**MODEL  
ERROR RESOLUTION DOCUMENT**

| 1. Originator:<br>Al A Eddebbbarh/ Shaoping Chu | 2. Date:<br>5/22/2008 | 3. ERD No.<br>MDL-NBS-HS-000020 ERD 02 |

| 4. Document Identifier:<br>MDL-NBS-HS-000020 REV02 AD 02 | 5. Document Title:<br>Particle Tracking Model and Abstraction of Transport Processes |

Figure 6.6.2-6[c] (a) and (b). Normalized Cumulative Breakthrough Curves of 6 Irreversible Fast Colloids and 6 Irreversible Slow Colloids for the Glacial-Transition 10th Percentile Infiltration Condition and Representative Parameter Values, with Colloid Filtration

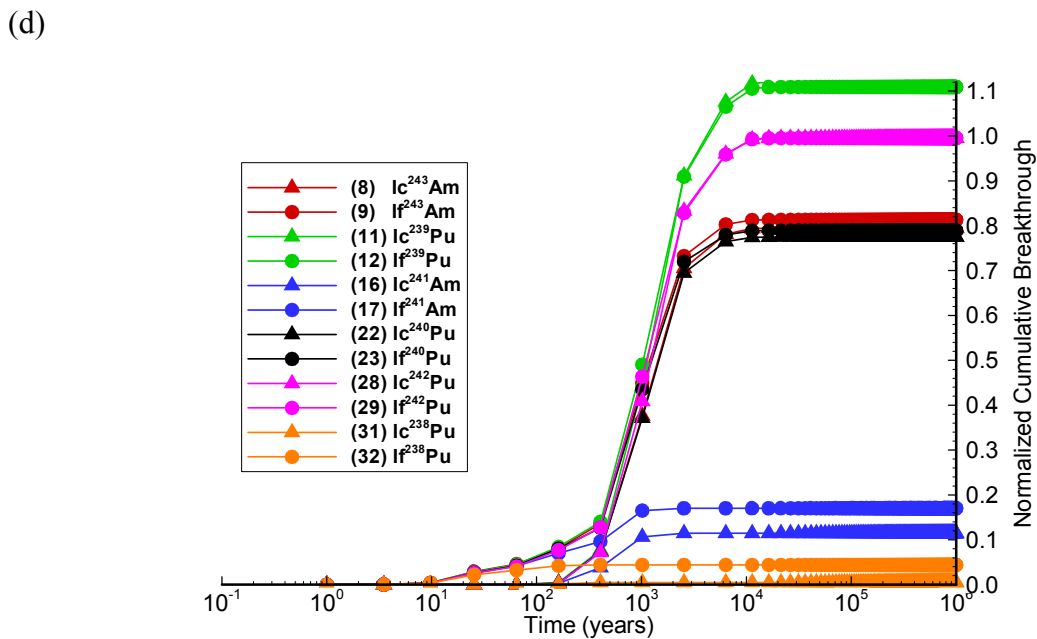
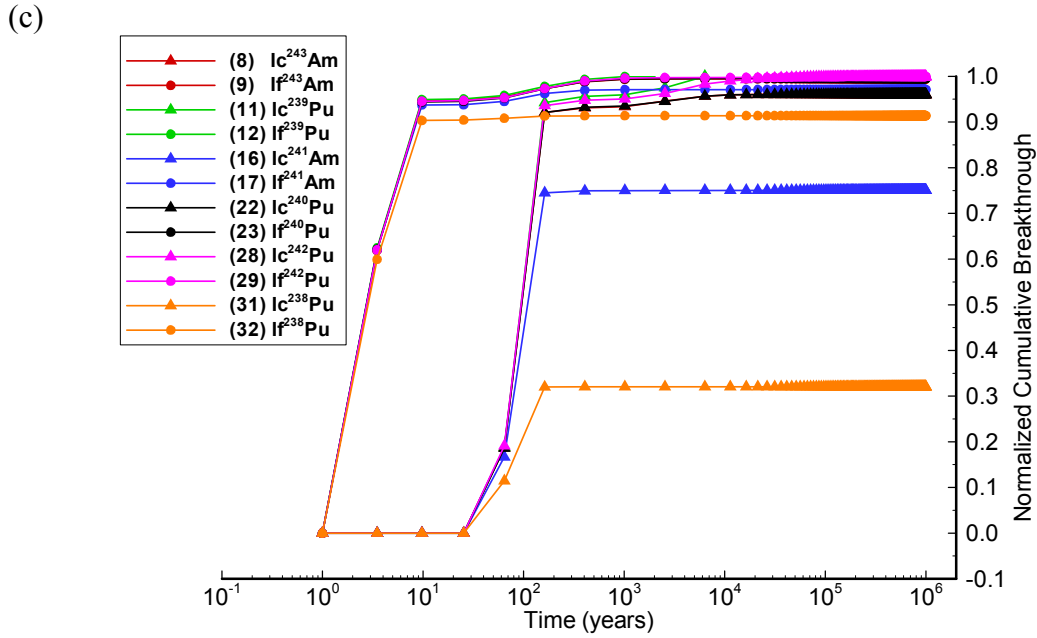
The results below replace the work in the third paragraph of MDL-NBS-HS-000020 REV 02 AD 02, Section 6.6.2.2[b]. Comparisons of breakthrough curves for 12 colloidal species (Ic and If species of  $^{243}\text{Am}$ ,  $^{239}\text{Pu}$ ,  $^{241}\text{Am}$ ,  $^{240}\text{Pu}$ ,  $^{242}\text{Pu}$ , and  $^{238}\text{Pu}$ ) released from both the locations are illustrated in Figure 6.6.2-6[c]. Note that the numbering of the sections and figures is intentionally consistent with the parent document. Figure 6.6.2-6[c] has four separate graphs; plots (a) and (b) present simulation results for the case including colloid filtration for the northern and southern release locations, respectively. The other two plots (c) and (d) present the simulation results for the case without colloid filtration for the northern and southern release locations, respectively. The simulation results for the case including colloid filtration (plots (a) and (b)) show that, as expected, radionuclides that are irreversibly attached to “fast” colloids (If species), which are not affected by matrix diffusion and retardation, have the shortest breakthrough times. At the northern location, within about 10 years after release, over 90% of the irreversible fast colloids travel through the unsaturated zone. Radionuclides that are irreversibly attached to “slow” colloids (Ic species), which undergo retardation due to colloid attachment/detachment processes, move more slowly than their corresponding fast colloid counterparts. The transport time of the irreversible slow colloids depends on the colloid retardation factor, a parameter that is explored more fully in MDL-NBS-HS-000020 REV 02 AD 02, Section 6.8.2[b]. Compared to the fast colloids released at the northern location, the first arrival times for the southern release location are about one order of magnitude larger, due to the thickness of the interval of unfractured rock governed by slower matrix transport. The cumulative breakthroughs for most of these irreversible fast colloids in the northern location are close to unity (except for Ic  $^{238}\text{Pu}$  and Ic  $^{241}\text{Am}$ ), whereas for the southern location, the cumulative breakthrough is significantly reduced for all radionuclides due to a combination of filtration at the interfaces of matrix units and radioactive decay. The filtration mechanism is more pronounced for the southern release location due to the prevalence of matrix-dominated flow in the south. In summary, most of the Ic and If colloidal species have very limited reduction due to decay in the unsaturated zone from the northern release location, whereas a larger proportion of the radionuclides decay or are subject to colloid filtration in the unsaturated zone before reaching the water table for the southern release location.

For the case without colloid filtration (plots (c) and (d)), the effect of removing colloid filtration is negligible in the northern area (compare plots (a) and (c)) because of the fast travel times. In the southern release area (compare plots (b) and (d)), the effect is more pronounced. Without filtration, a greater portion of the radionuclides attached to colloids will exit the flow system before they decay. The results presented in Figure 6.6.2-6[c](d) are explained by the differences in the half life of the elements. The shortest half life elements  $^{238}\text{Pu}$  and  $^{241}\text{Am}$  decay quickly and a small portion of Ic and If remain to exit the flow system. Longer lived elements such as  $^{242}\text{Pu}$  show almost no decay before the Ic and If portions exit the flow system. The normalized

Figure 6.8.2-23[c](#1). Mean Travel Time of  $I_c^{240}\text{Pu}$  as a Function of Colloid Retardation Factor for the Glacial-Transition Climate Condition, with Colloid Filtration: (a) is the northern release location and (b) is the southern release location

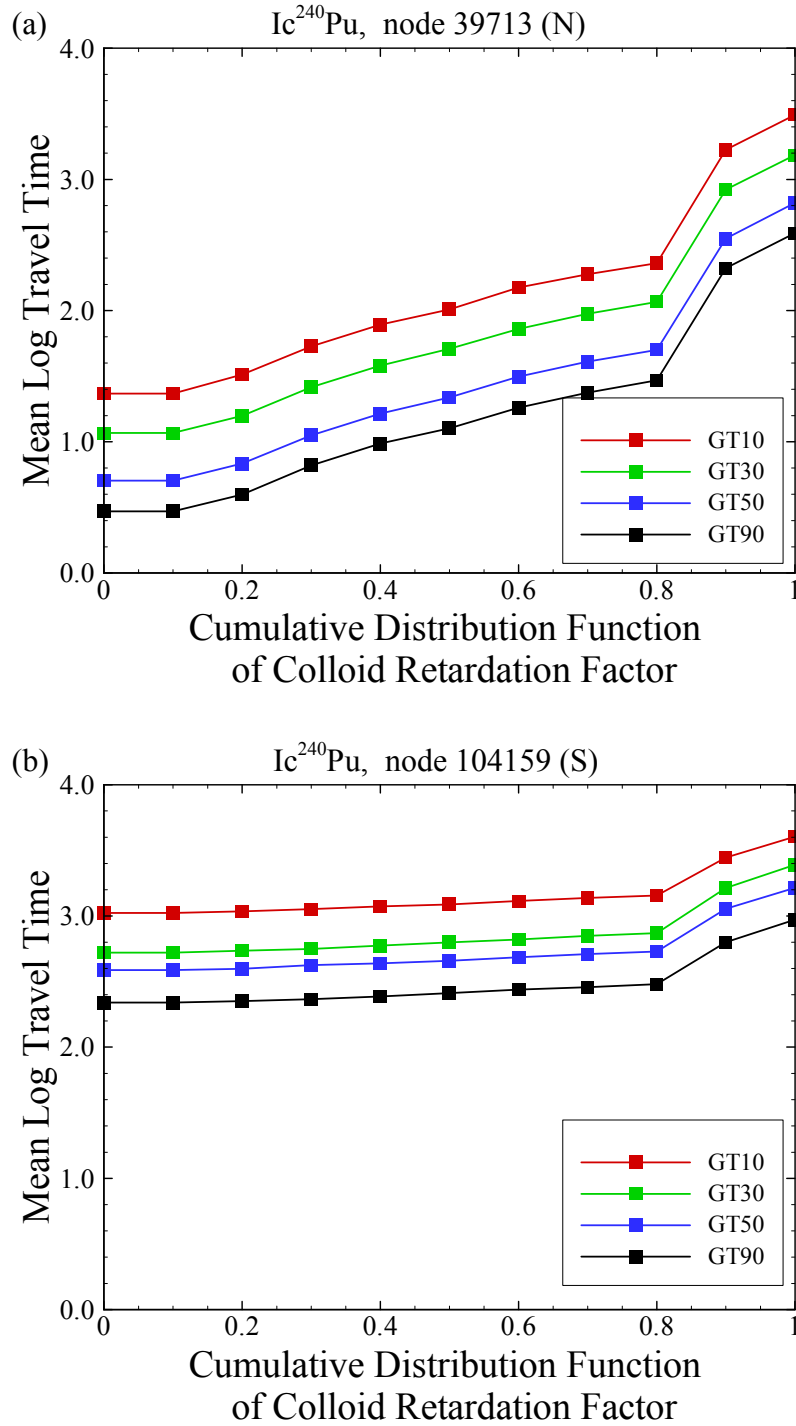
The following set of analyses examines the influence of uncertainty in the value of the colloid retardation factor  $R_{\text{coll}}$  for the irreversible Ic species of  $^{240}\text{Pu}$ . Figure 6.8.2-23[c](#1) (with colloid filtration) and Figure 6.8.2-23[c](#2) (without colloid filtration) show the results of the mean travel time as a function of  $R_{\text{coll}}$  for the four glacial-transition flow fields, for the northern (top) and southern (bottom) release locations. Similar plots for the decay fraction  $C/C_0$  are shown in Figure 6.8.2-24[c](#1) (with colloid filtration) and Figure 6.8.2-24[c](#2) (without colloid filtration). For the with filtration versions of both figures, the results are slightly different than the corresponding figures in Addendum 01 of the parent document, but the conclusions in that document are still valid.

Comparing the results with and without colloid filtration, the results without colloid filtration are slightly different than the corresponding figures in Addendum 01 of MDL-NBS-HS-000020 REV 02 AD 02, but the conclusions reached in that document are still valid. For the northern release location, travel times are larger for either lower fluid flow rates or larger values of  $R_{\text{coll}}$ . The southern release location, with its interval of matrix-dominated transport, has generally larger travel times and a smaller impact of fracture retardation of colloids, since this effect “competes with” the matrix transport time for importance. For either release location, the decay fraction is close to unity for this species of  $^{240}\text{Pu}$  except for the highest values of  $R_{\text{coll}}$  in the uncertainty distribution. For other Ic species with shorter half lives, a larger effect of  $R_{\text{coll}}$  uncertainty on the decay fraction would be expected. There is very little impact of colloid filtration on the travel times of Ic species of Pu through the flow system. As was observed above, the effects are relatively larger in the southern release location than in the northern release location.

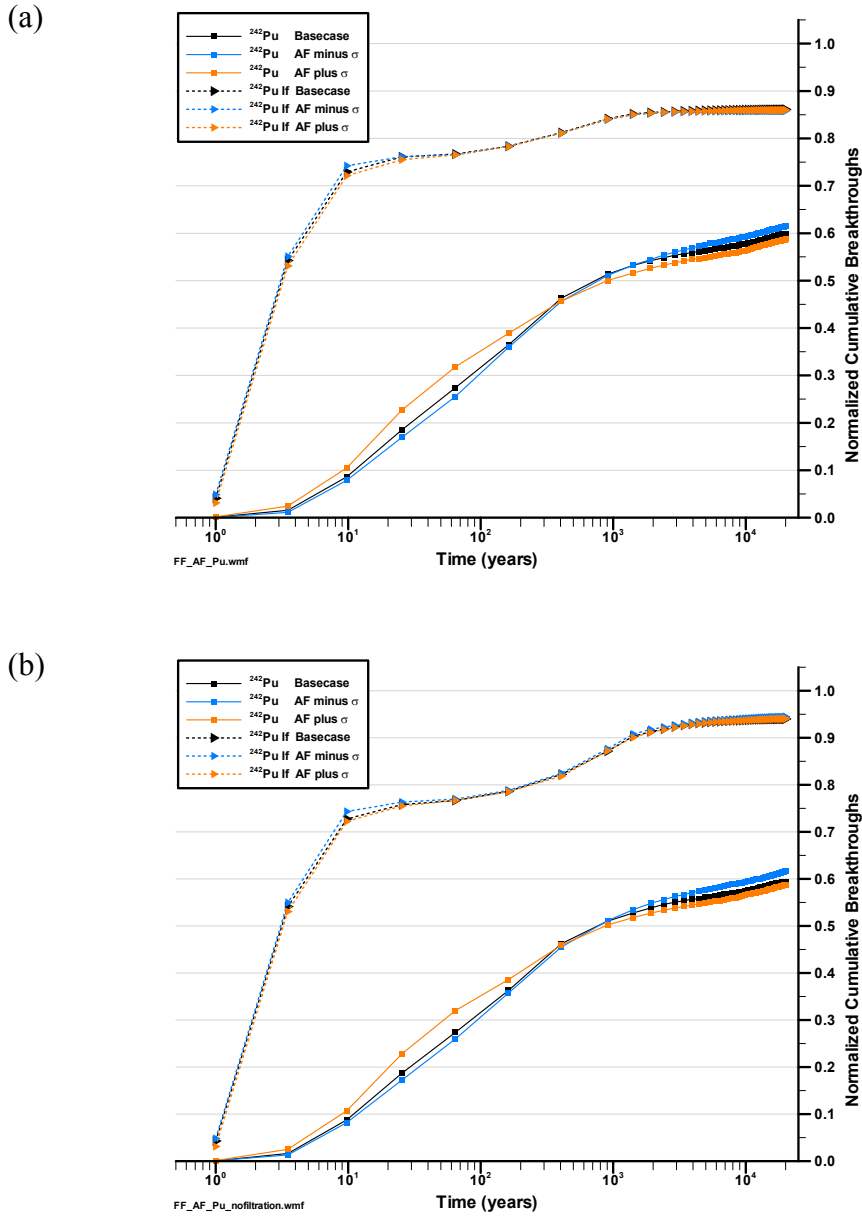
As noted earlier, figure numbers correspond to the section of the parent document. Figure 6-26[c] contains the results of simulations varying the value of the van Genuchten parameter  $\alpha$  for the fracture continuum. The upper plot (a) includes colloid filtration while plot (b) is without colloid filtration. For the dissolved species, the results are the same as expected. For the irreversibly sorbed radionuclide  $\text{I}^{242}\text{Pu}$ , the normalized cumulative breakthrough increased from about 0.86 to 0.94. Comparing the two groups of results (with and without colloid filtration), the case without colloid filtration shows more breakthrough at later time, but the conclusions reached in the parent report are still valid.

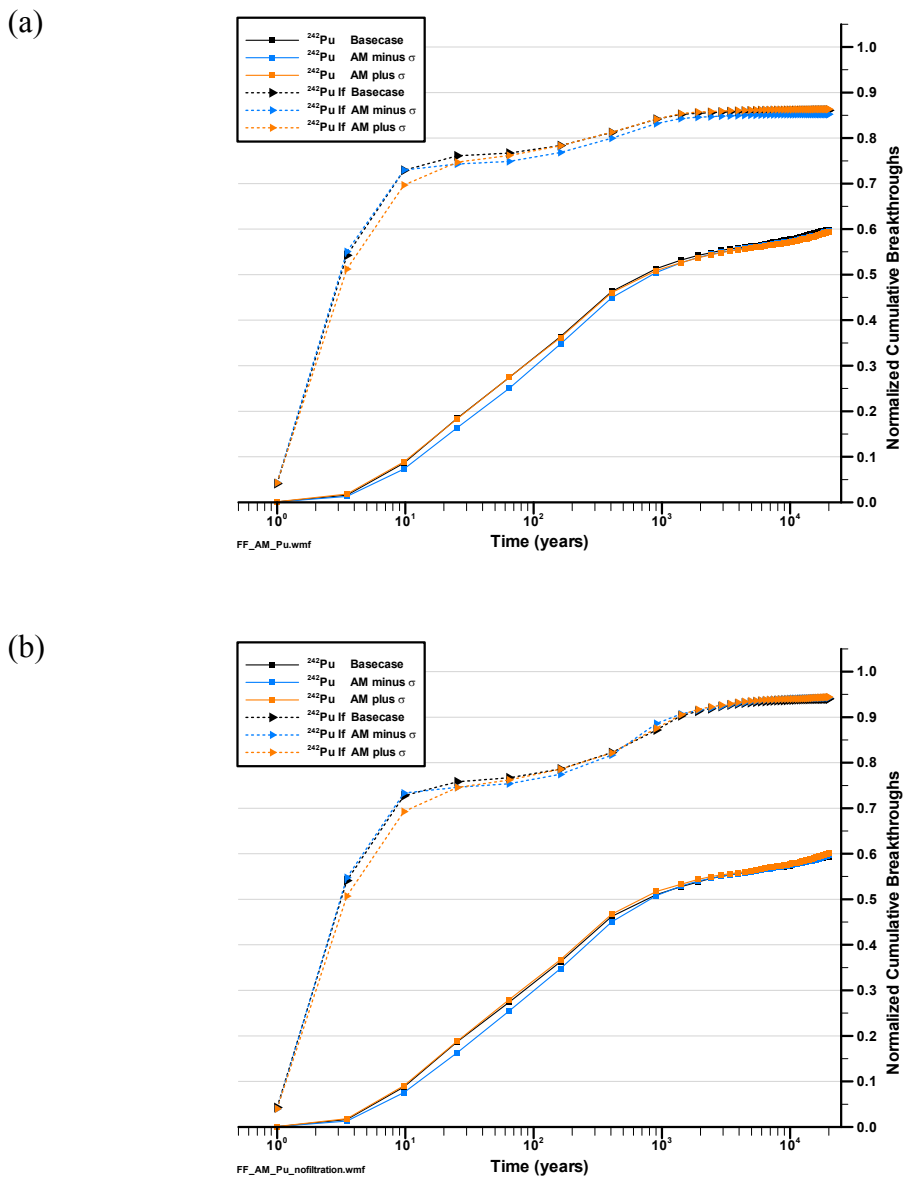
Figure 6-28[c] shows similar results for the case of varying the van Genuchten parameter  $\alpha$  for the matrix continuum. The results for both the case including colloid filtration and the case without indicate that the van Genuchten parameter  $\alpha$  for the matrix continuum has very little impact on predicted transport of radionuclides.

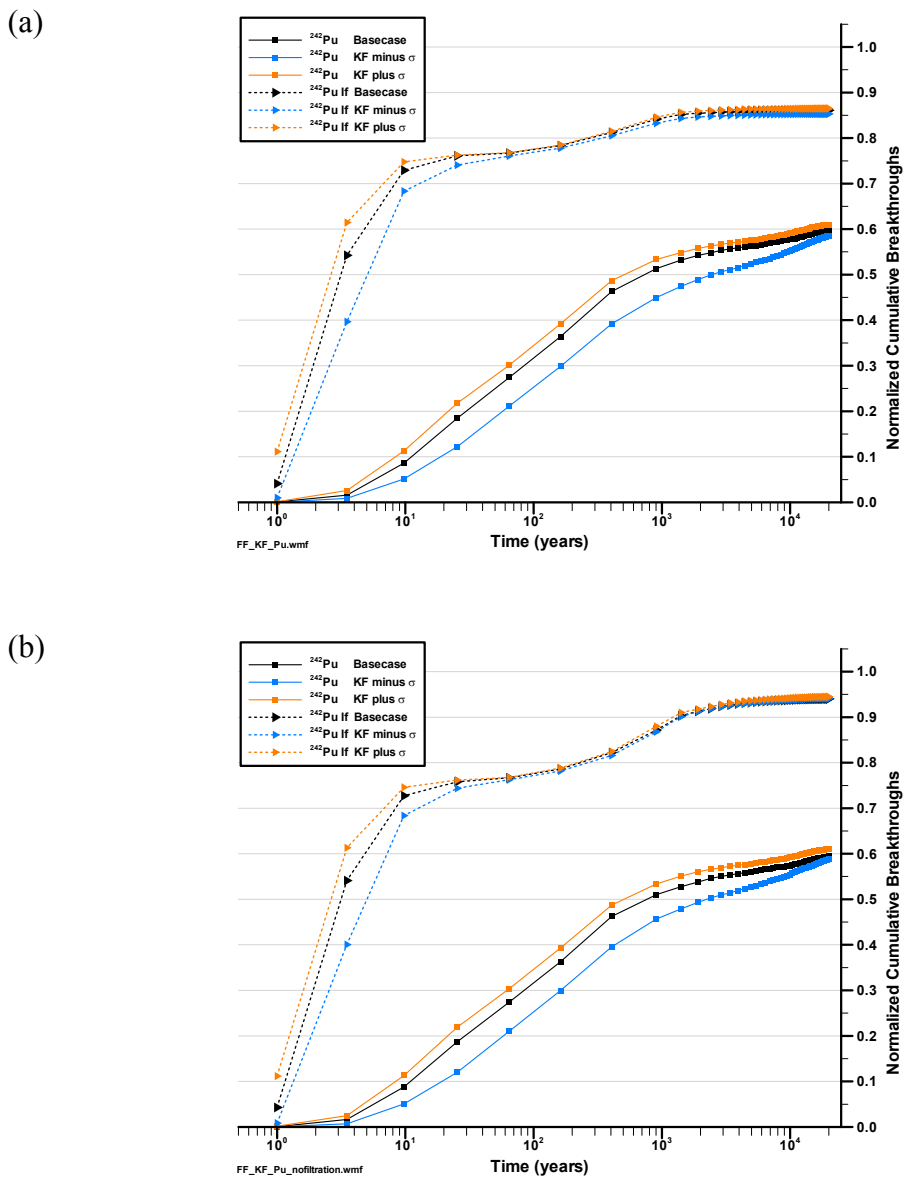
The impact of changing the absolute permeability of the fracture continuum is shown in Figure 6-30[c]. The case including colloid filtration (a) has slightly less normalized cumulative breakthrough than for the case (b) without colloid filtration. The difference in the late time normalized cumulative breakthrough (about 0.86 versus 0.94) is the same as the previous two figures and shows that without colloid filtration a slightly greater amount of irreversibly sorbed radionuclides will exit the flow system.

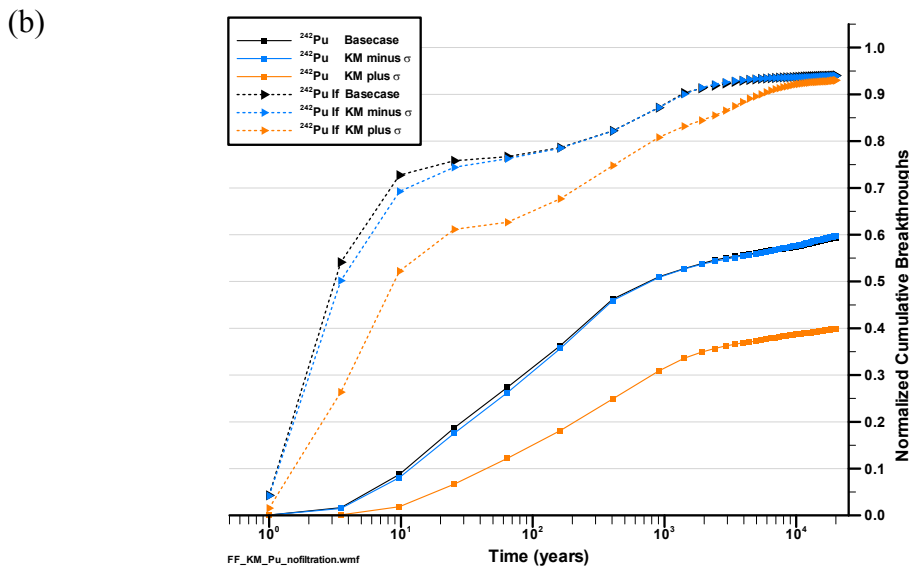
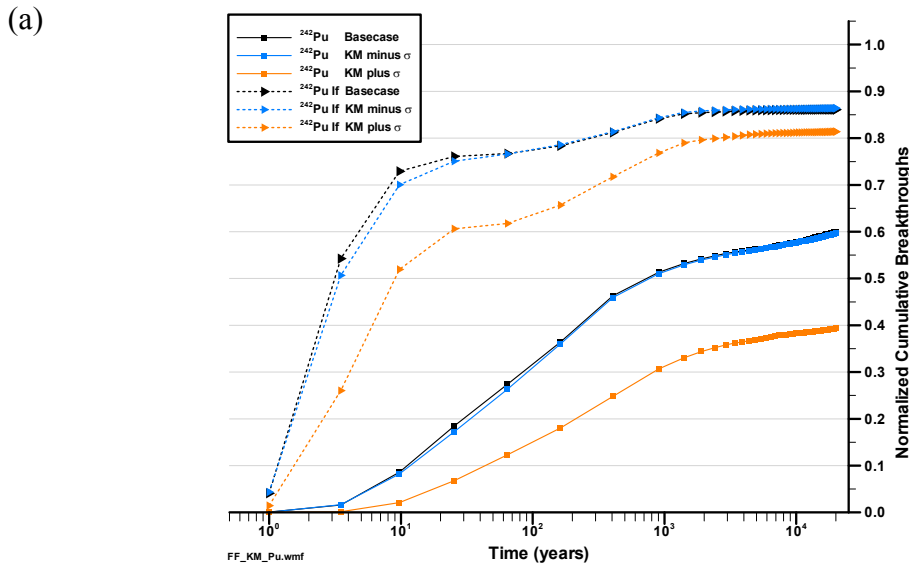
The final comparison is presented in Figure 6-32[c], where the sensitivity of predicted transport to varying the absolute permeability of the matrix rocks is presented. The case including colloid filtration (a) is compared with the case without colloid filtration (b). As in the previous figures, colloid filtration has no impact on the dissolved species. As well, the late time normalized cumulative breakthrough increased to about 0.94 for the case without colloid filtration. One final observation is that in the case including colloid filtration (a), increasing the absolute permeability

increased the travel time and produced a different normalized cumulative breakthrough at the end of the simulation. Without colloid filtration (b), the travel times are also longer, but by the end of the simulation, the normalized cumulative breakthrough are nearly the same.
